6.1 Planning Permit Application TP-2024-854 23-31 Lincoln Square South, Carlton**Report Author:** Leanne Stockley, Senior Urban Planner**Report Presenter:** Nick McLennan, Acting Head of Statutory Planning**Executive Leader:** Evan Counsel, General Manager Strategy, Planning and Climate Change**Executive Summary**

1. The purpose of this report is to advise the Future Melbourne Committee of a planning permit application that seeks permission for partial demolition, development of a multi-storey building used for student accommodation and retail, and a variation of the bicycle facility requirements at 25-31 Lincoln Square South, Carlton (refer to Attachment 1 – Locality Map).

Application Number	TP-2024-854
Address	23-31 Lincoln Square South, Carlton
Applicant Owner Architect	Fathom Lincoln Pty Ltd Ambertree Vic Mel (Lincoln) Pty Ltd Hayball
Proposal	Partial demolition, use and development of the land for student accommodation in a multi-storey building, and a waiver of the bicycle facility requirements
Cost of Works	\$40.12 million
Planning Controls	Capital City Zone – Schedule 5 Heritage Overlay – HO1122 Design and Development Overlay – Schedule 61 Parking Overlay – Schedule 1
Per

Figure 9 – Excerpts of north (left image) and east (right image) elevations of the proposal (Source: Hayball – revision 2, dated May 2025). Green highlight by officer.

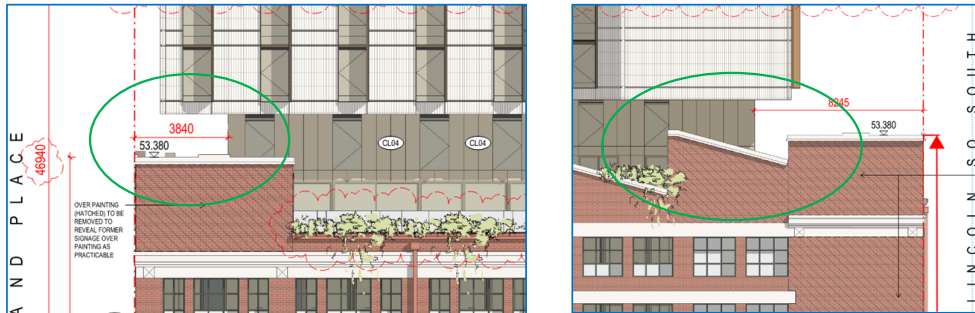
Recommendation – On the east elevation provide a backdrop from the tower to the sawtooth walls, which will retain the prominence of the saw-tooth forms.

In response to the Heritage Advisor's comments on the proposed height, design changes have been explored to achieve a more modest building form. The applicant notes that reduction in height cannot be achieved where host building slab heights are retained for benefit of activation, ESD response, and interpretation of the heritage form. Retaining the slabs in situ restricts the ability to compress the floor to ceiling heights that could usually assist in overall reduction of built form. The applicant also tested revision to setbacks of the transition floors (including an additional floor), however this resulted in further unbalanced appreciation of the addition when viewed from the north west.

The applicant has now proposed an increase to the eastern side setback at the northern portion of the elevation. The application plans currently propose a setback of 1.03 metres to the side boundary, at level 7, which results in the building form positioned above the east sawtooth, with a small setback, as seen below:

As noted above, the vicinity of the upper addition to the sawtooth is noticeable most prominently at this north east corner of the host building.

The recommendation to provide depth to tower façade along the east elevation behind the saw-tooth walls is discussed in section 9.2.3 of this report.

Figure 11 – Excerpt of north elevation of the proposal noting glass balustrade behind parapet (Source: Hayball – revision 2, dated May 2025).

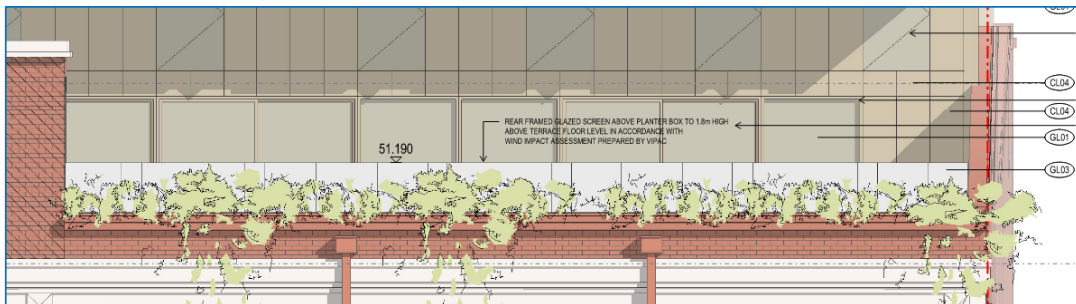
Recommendation – Delete or substantially set back the balustrade/s proposed to the parapet at the north and east elevations.

Concern was raised by the Heritage Advisor around the possible visibility of balustrading behind the host building parapets, and for the addition of rooftop plant structures.

With regard to the balustrades, the north elevation is proposed to include a 1.8 m high glazed screen (effectively a clear un-capped balustrade) set back 1.2 m behind the host building roof parapet, see below:

The recommendation to delete or set back the balustrade/s is discussed in section 9.2.5 below.
